UNITED STATES PATENT AND TRADEMARK OFFICE

Office Action Summary

10/602,286

BAUMAN, WALTER DOUGLAS

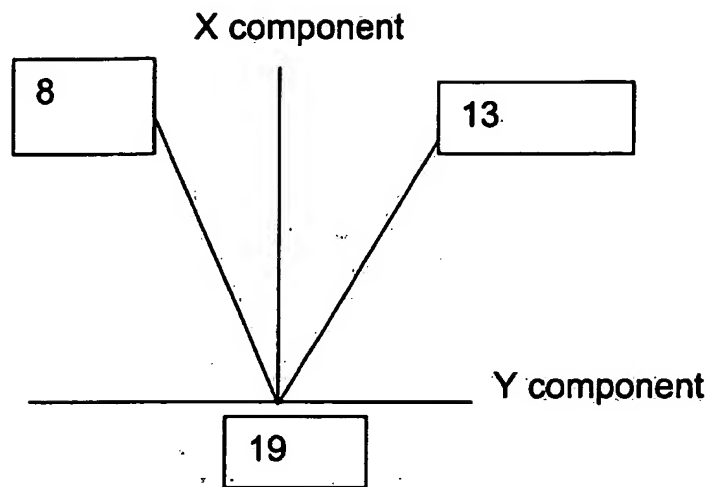
Taunay discloses:

Vehicle closure member 1, Arm 9 with first segment between pivot point 8 and pivot point 19 and second segment between pivot point 13 and pivot point 19, extension member 12, gas spring 5 with two segments, hinge assembly 3, roller 17

Taunay discloses biasing the roller against the vehicle closure member in column 2 lines 55-58.

The second segment is directly in contact with the closure member through intermediate parts in the exact same way as the instant invention (roller is between the closure member and the second segment of the arm).

Regarding claims 18 and 19, examiner refers to the following figure

The two segments extend in opposite and parallel directions along the y axis in the exact same way that the instant invention does. The instant invention is not a straight bar but is a "W" shape. The legs of the segments extend in both the x and y directions in the same way as the link of Taunay.
